Mad Island WMA- ADA Evaluation

Accessibility Evaluation

Inspection Date: 07/28/2022

Report Date: 01/17/2024

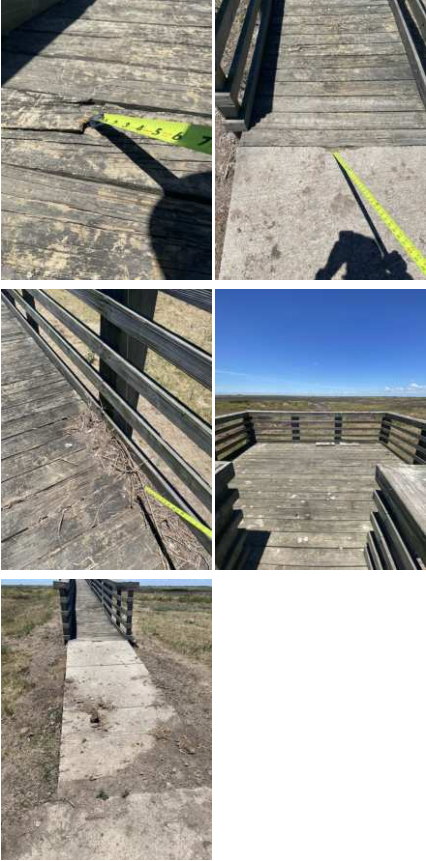
Finding Number	Area Description	Finding	As Built	Recommendation	Citation	Photos	Figure
19	Structures on Property (Public) : Cleaning/Check Station - Pathway to Cleaning/Check Station	The path of contains multiple issues and is not accessible. The path of travel exceeds the maximum allowable cross and running slope requirements. It also contains changes in level and/or gaps that exceed the allowable maximum requirements. The path of travel does not meet the minimum width requirements for clearances, turning spaces, and/or passing spaces. The floor or ground surface is not firm, stable, and slip resistant.	Due to terrain and change in elevation pathway is not compliant This element is not accessible	Review accessible pathway componets to make accessible https://www.access-board.gov/ada/#ada-402 https://www.access-board.gov/ada/#ada-403_1	2010 ADAS Section: 403.1 2015 ABAAS Section: 403.1
